CLINTON CREEK ASBESTOS MINE

WASTE DUMP AREA

REVIEW OF REHABILITATION MEASURES

Prepared For
INDIAN AND NORTHERN AFFAIRS
Yukon Water Board

FIGURE 1 CLINTON CREEK WASTE DUMP
AVERAGE HORIZONTAL MOVEMENTS
TOE OF MAIN DUMP SEGMENT

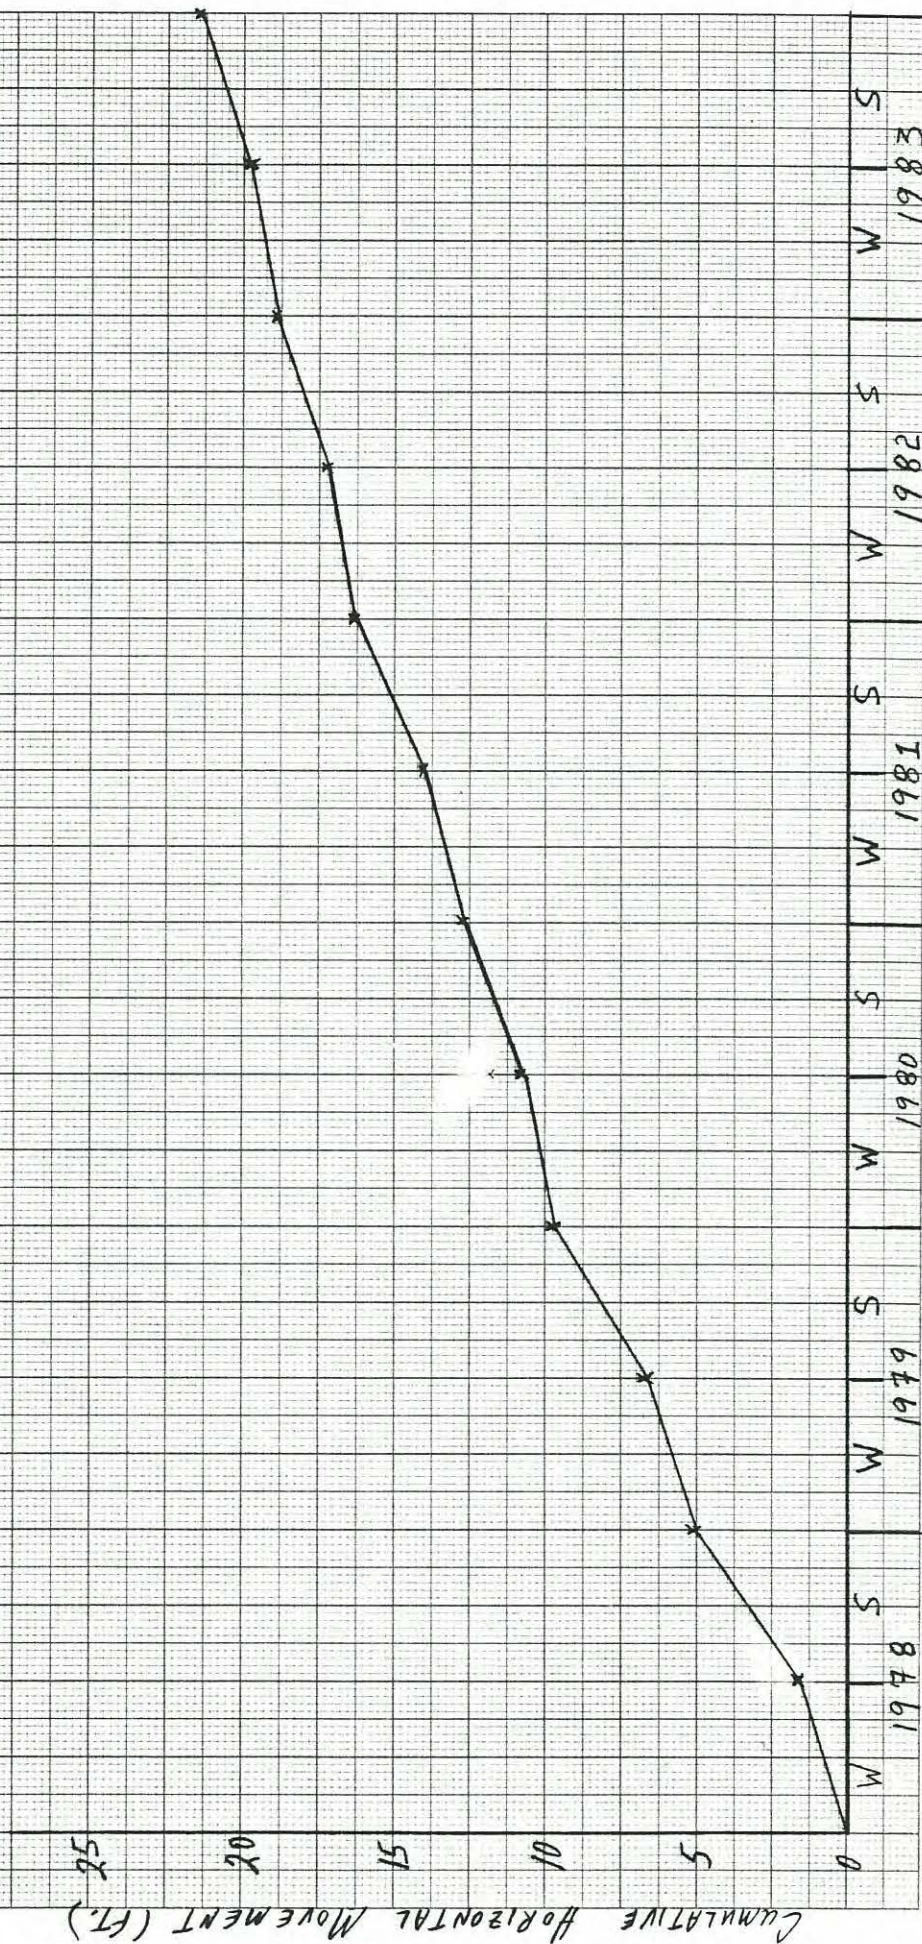
Figure 1 shows a plot of movements at the toe of the main dump segment. Horizontal movements are currently in the order of 0.75 m per year (2.5 ft/yr). These movements have been relatively constant over the past three years. Average vertical movements are less than 0.3 m per year (1 ft/yr) at the toe of the dump.

FIGURE 2 CLINTON CREEK WASTE DUMP

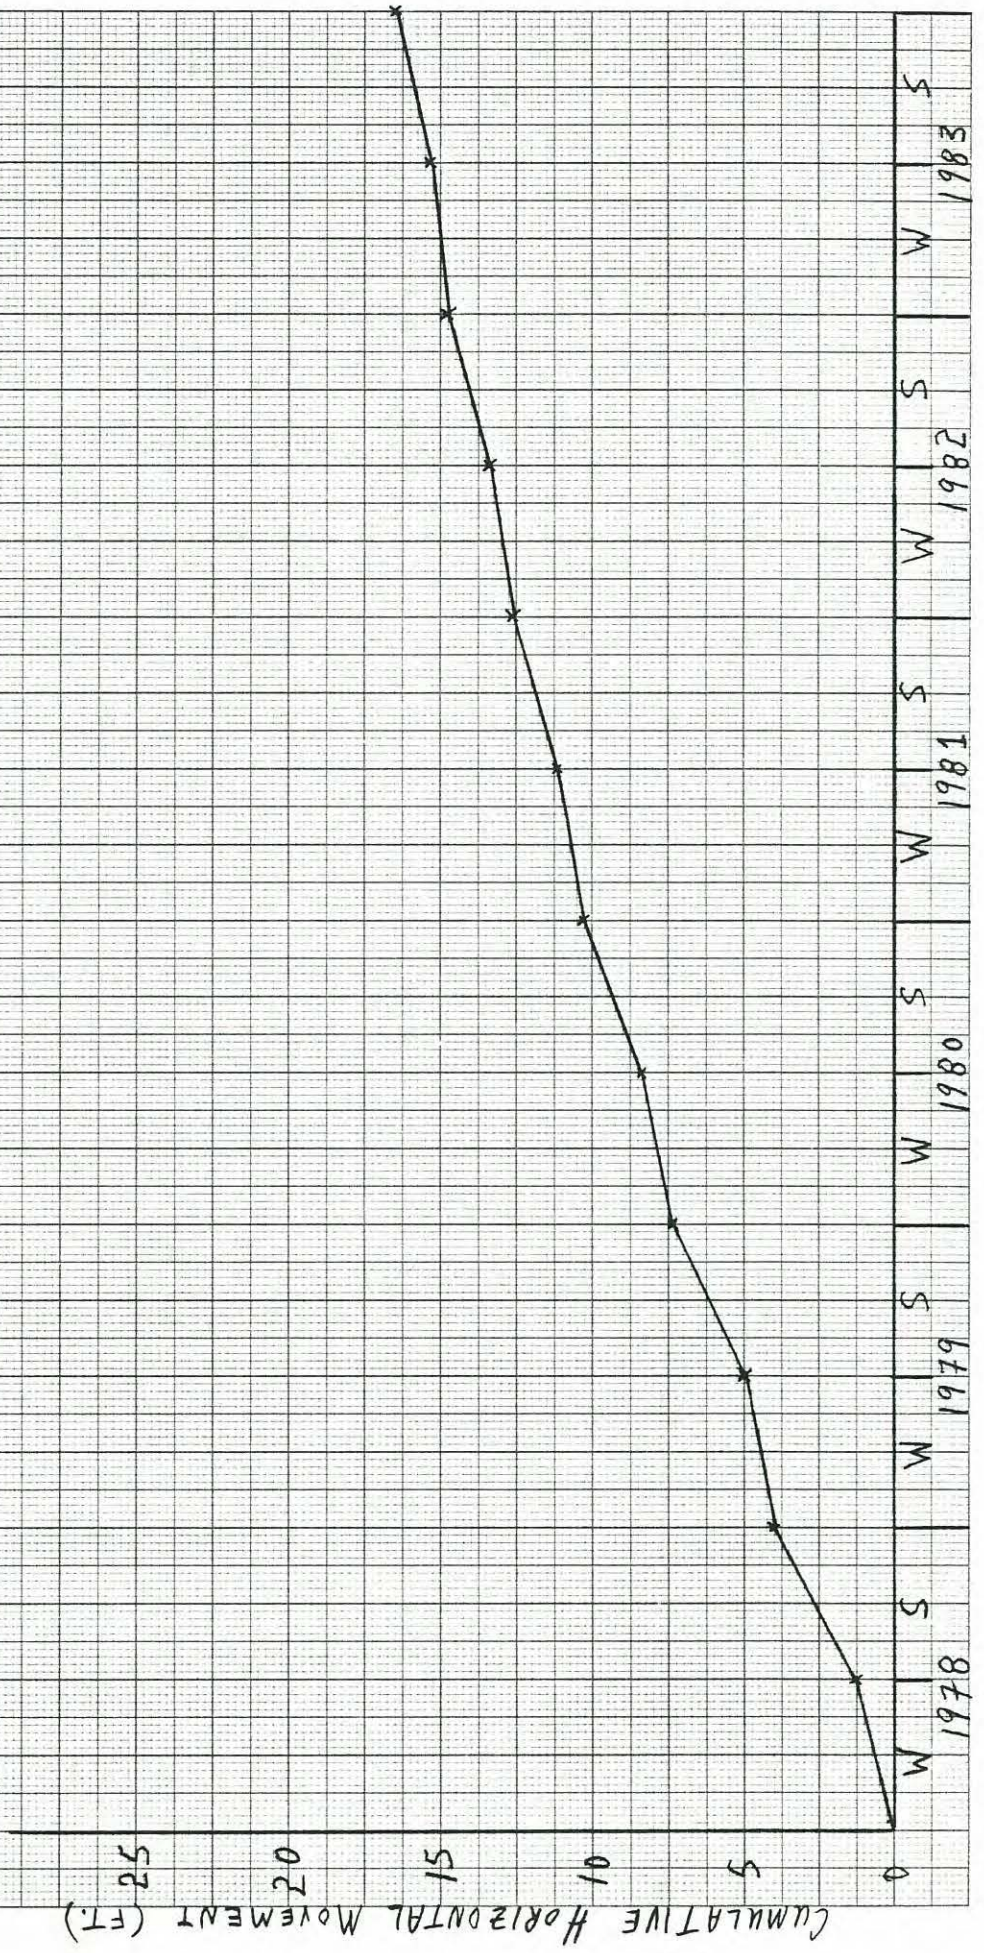
Creek closure measurements are plotted on Figure 2. Closure movement is currently in the order of 0.6 m per year (2 ft/yr). Again, movements have been relatively constant over the past couple of years.

PLATE A1

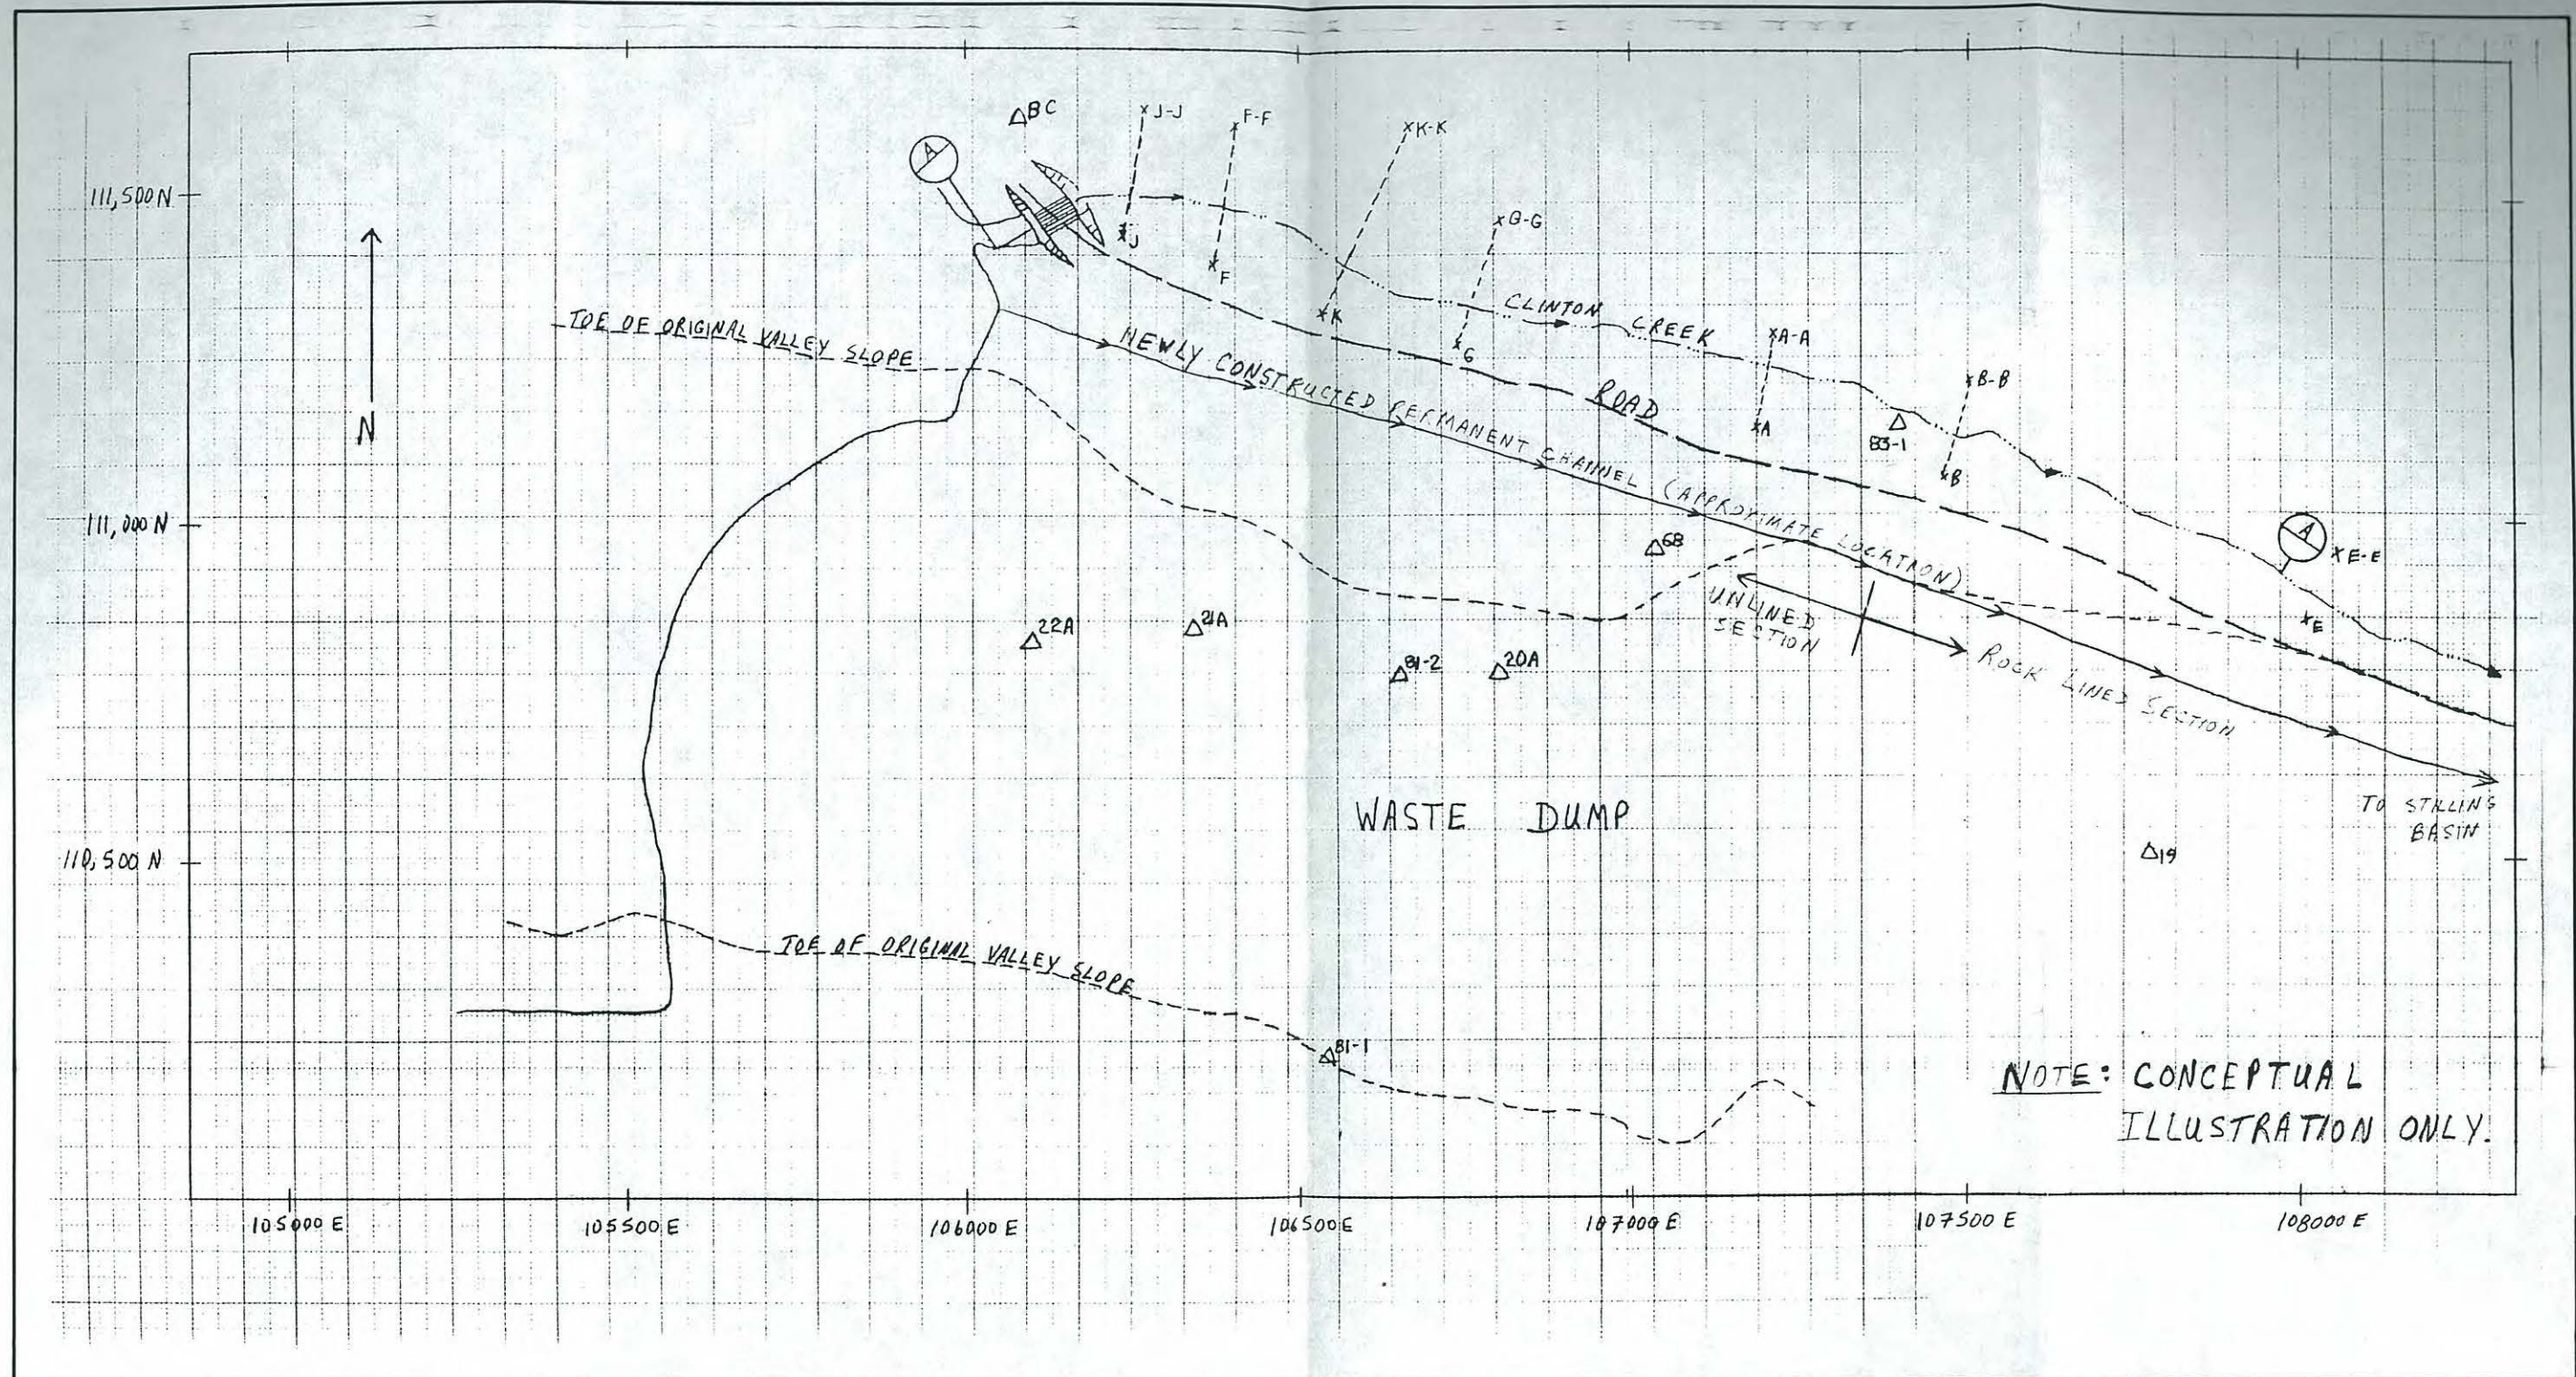
A detailed slope stability analysis would be required to determine the amount of fill required to achieve stabilization. As a rough estimate, it is believed that raising the creek channel elevation by about 15 m (50 ft) would be adequate. This estimate is based on the inferred slope cross-section shown on Plate A1. The slope section presented has been based on available photographs and reports discussing the site conditions. A proper survey of the present dump profile would be necessary prior to detailed analysis.

Plate A1 shows the original valley and slope configuration, the inferred waste dump surface profile and the proposed cut and fill areas. The estimated fill volume for stabilization is in the order of 150,000 m³.
